**CFCC Phase II
RFI LOG**

Cape Fear Community College
Health and Human Services Building
Interior Renovation - Phase Two
319 N 3rd Stree, Wilmington, North Carolina 28401
SCO # 23-27149-01A NCCCS # 2772

1 Fifth Floor - Renovation
 Scale: 1/8" = 1'-0"

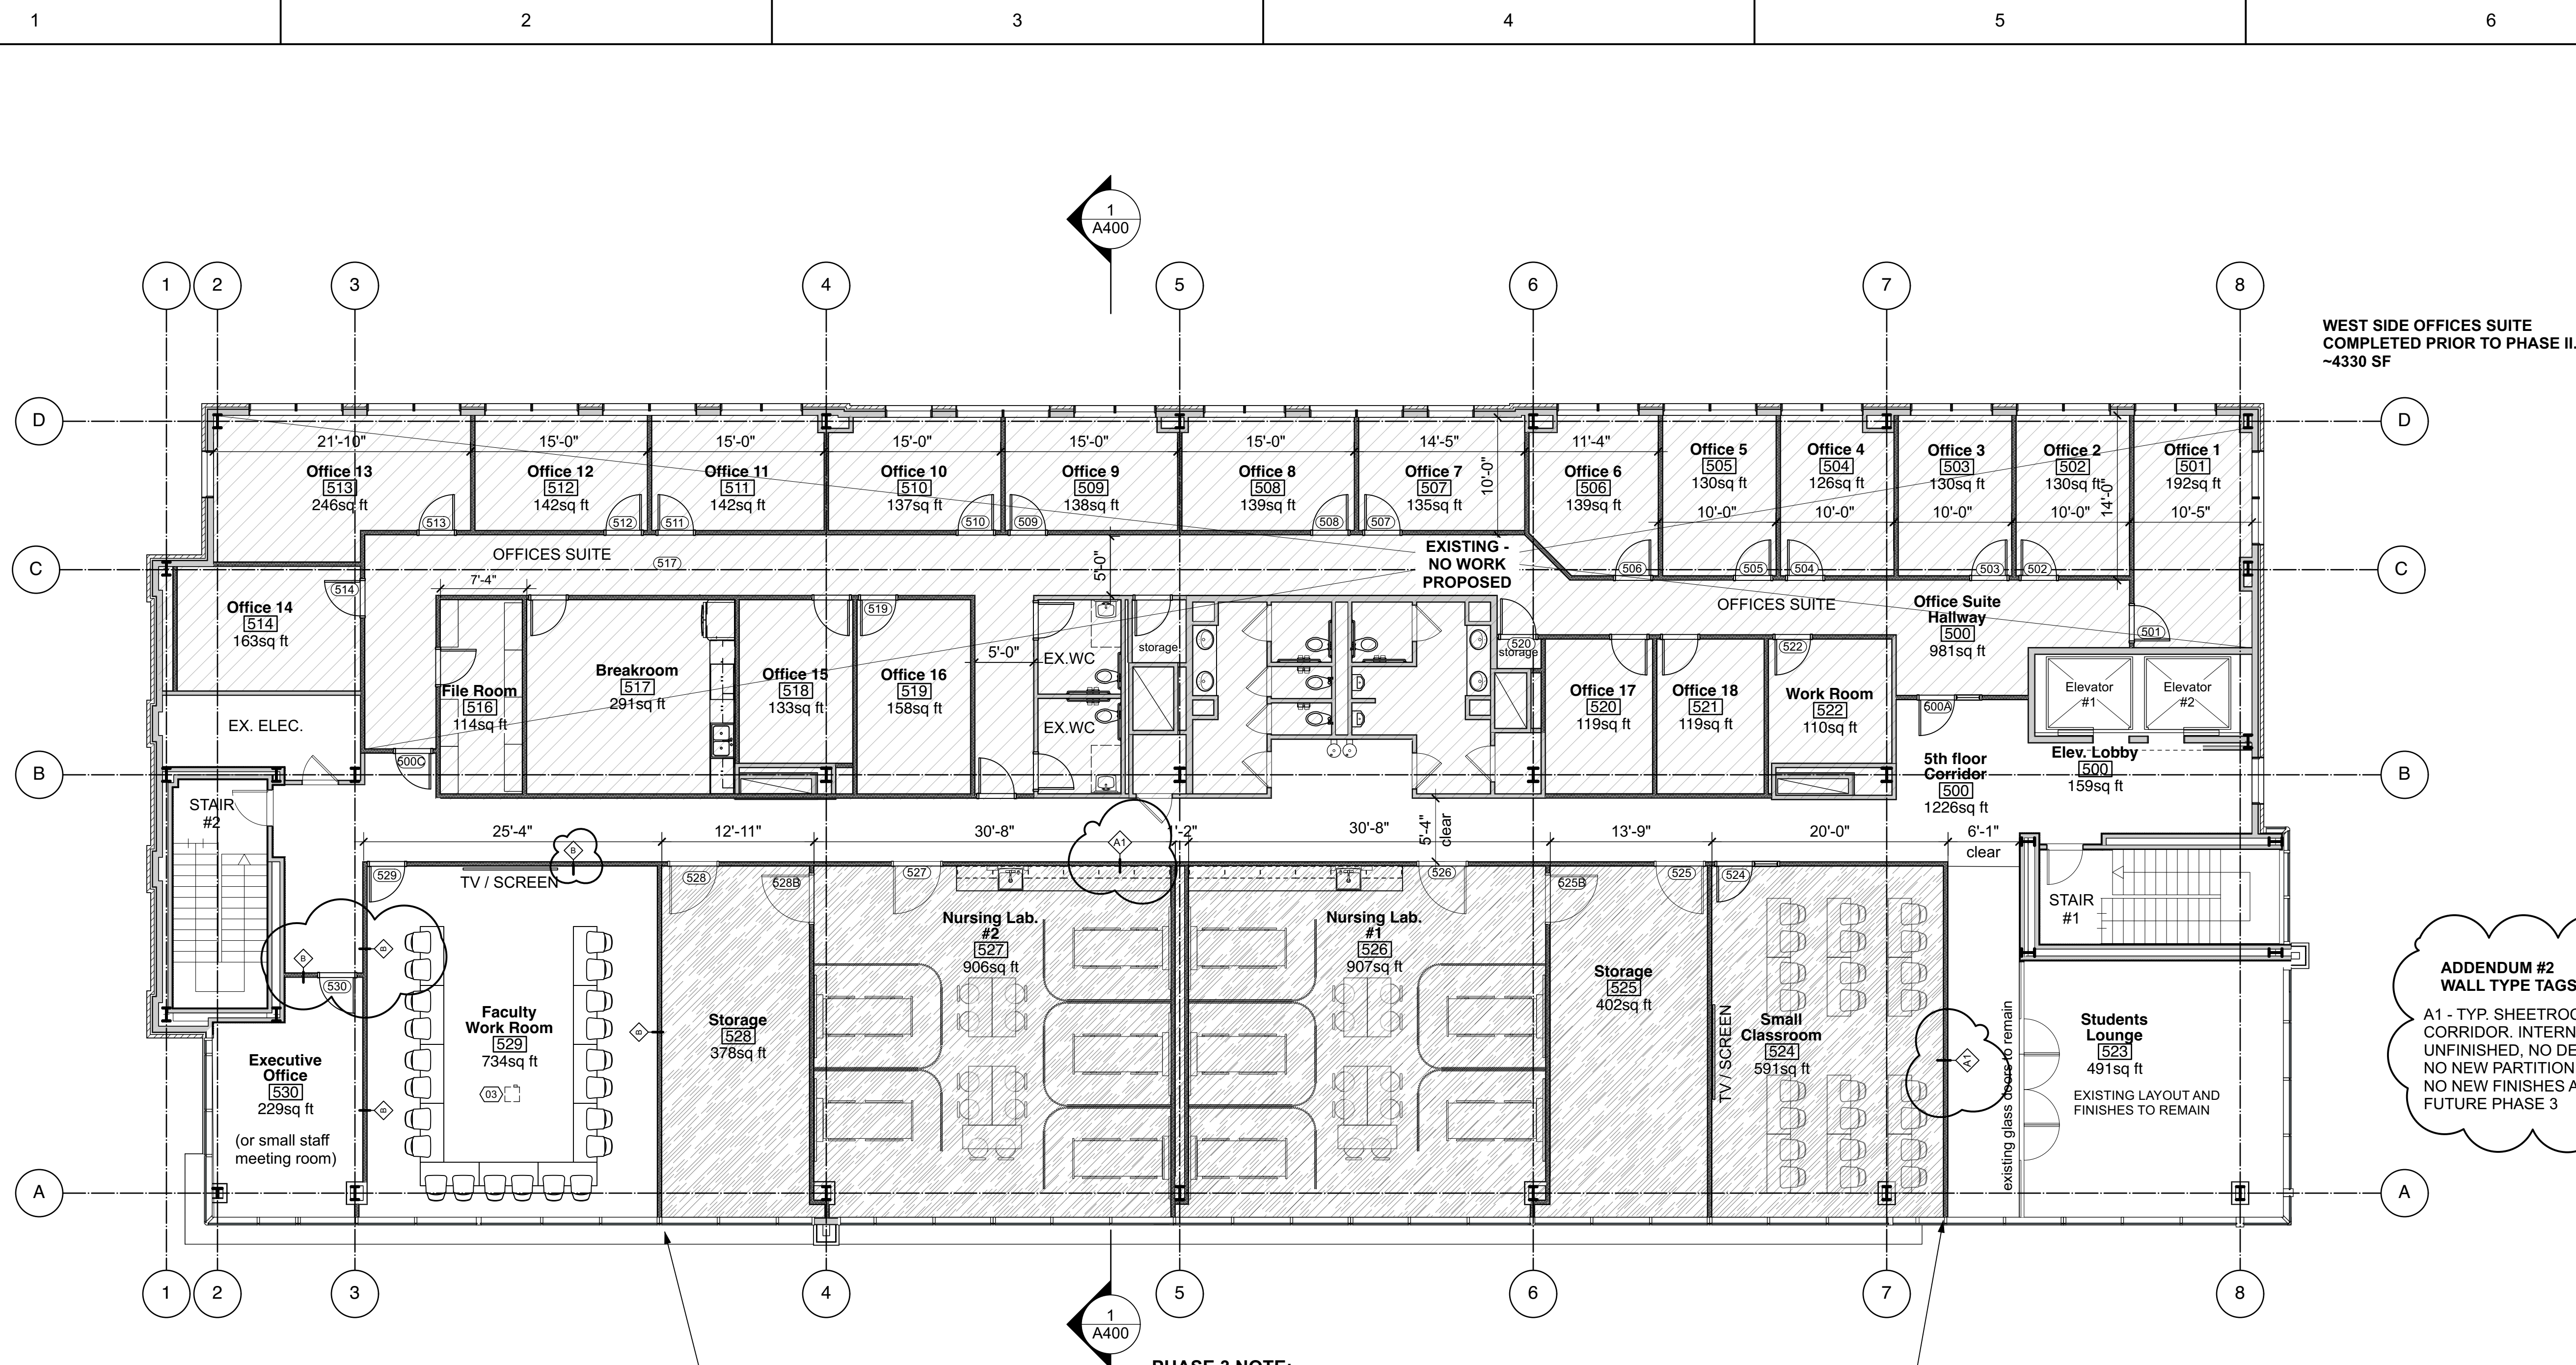
20	Drywall	Partitions on A202, A204, A205, A105 are not tagged with wall types. Please provide.		7/18/2024	7/18/2024	See addendum 5 for these drawings.
21	Drywall	Is all the perimeter exterior wall drywall & insulation existing to remain? Assuming we just need to patch.		7/18/2024	7/18/2024	patch and repair as needed for new work, otherwise existing exterior wall drywall and insulation can remain.
22	Drywall	A105 & A805. Please confirm scope of work for BP09A in the shaded "Shell" spaces rooms 524-528. Assuming we are to provide stud framing for all walls & GWB at corridor perimeter only, one side. A805 shows finished ceilings in these areas with no note referencing it being a shell.	A105 & A805	7/18/2024	7/18/2024	intent is to frame and one side finish the corridor 500/room 529 walls only. Rough in the water/DWV for the sinks and stub into space. Doors/frames hardware on the wall adjoining corridor 500 only. Otherwise, no demolition or new construction, partitions, ceilings within rooms 524-528. G23

**ADDENDUM #2
 WALL TYPE TAGS**
 A1 - TYP. SHEETROCK FACING
 CORRIDOR, INTERNAL SHELL,
 UNFINISHED, NO DEMOLITION,
 NO NEW PARTITION WALLS,
 NO NEW FINISHES AT THIS TIME.
 FUTURE PHASE 3

PHASE 3 NOTE:
 ROOMS 524-528 SHELL, METAL STUDS BUILT IN
 PHASE 2. INSTALL DOORS IN PHASE 2. PROVIDE
 WATER CONNECTION TO FUTURE SINKS.
 SPACES FIT-OUT, INTERNAL SHEETROCK, PAINT,
 MILLWORK, FURNITURE, FLOOR FINISHES TO BE
 COMPLETED AT LATER PHASE 3.
